TRANS/WP.29/GRSP/2004/7
20 February 2004

PROPOSAL FOR DRAFT CORRIGENDUM 2 TO SUPPLEMENT 15 TO
THE 04 SERIES OF AMENDMENTS TO REGULATION No. 16

(Safety-belts)

Transmitted by the Expert from the International Organization
of Motor Vehicle Manufacturers (OICA)

Figure 3 – ISO/F2x envelope dimensions for a reduced-height second version back surface shape forward-facing toddler CRS, (height 650 mm) – ISOFIX SIZE CLASS B1"

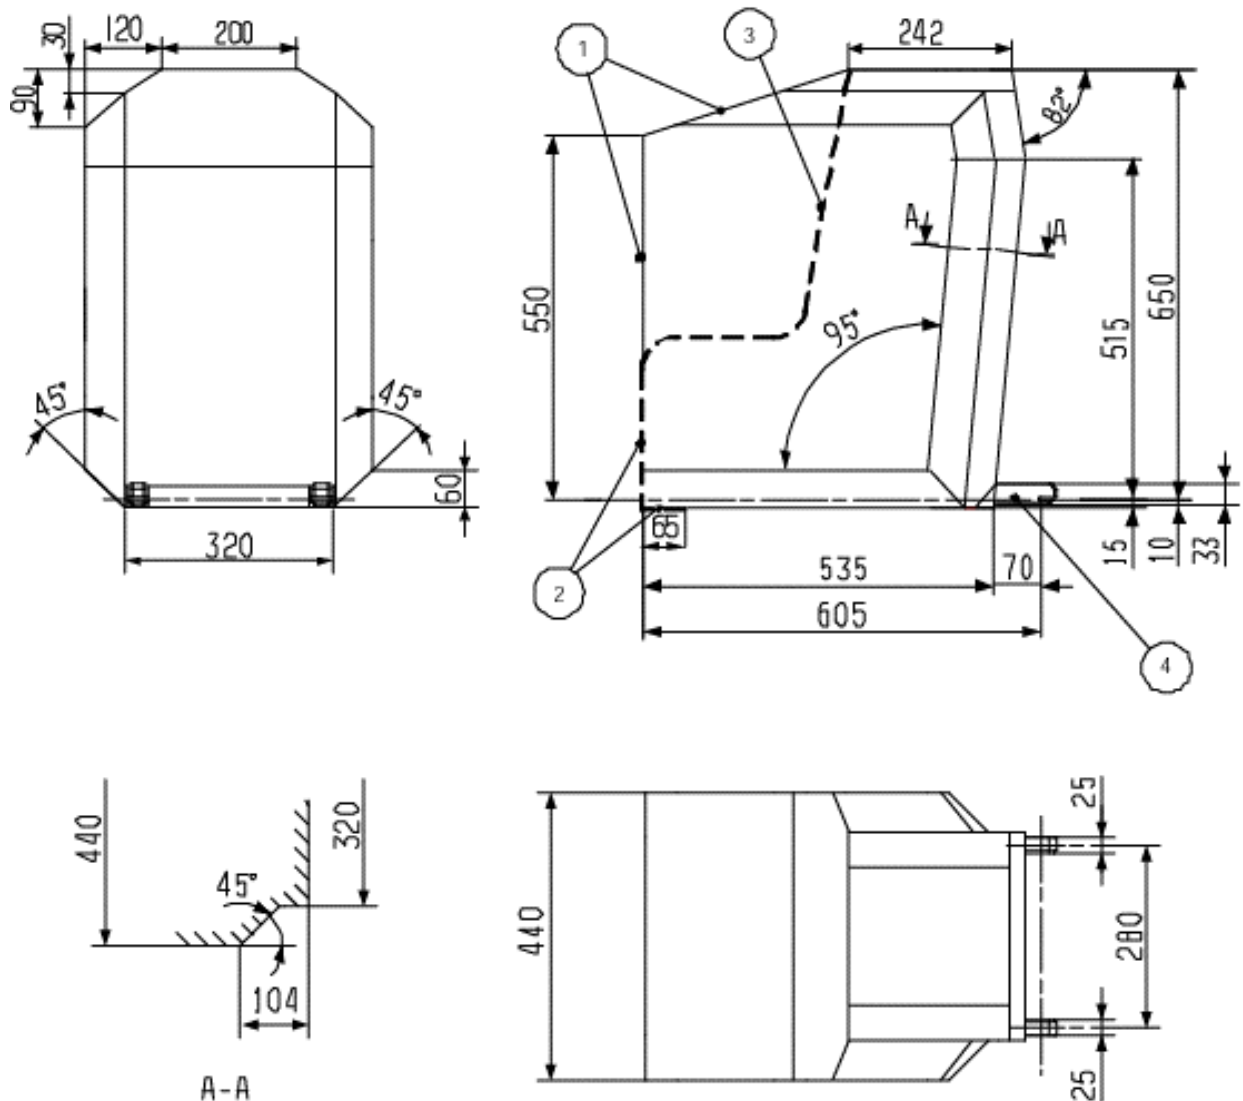
Paragraph 4.3., amend to read:

"4.3. Reduced-height second version back shape forward-facing toddler child restraint systems envelope

In order to solve such problem, the shape of CRF-F2x needs to be revised: the corner of the upper part of the back has to be cut. This has no influence whatsoever on the impact performance (the CRS themselves do not need to be changed). It is noted that the CRS of class B1 that fit into the current envelope as defined in CRF-F2x, do also fit into the modified CRF-F2x as proposed above.
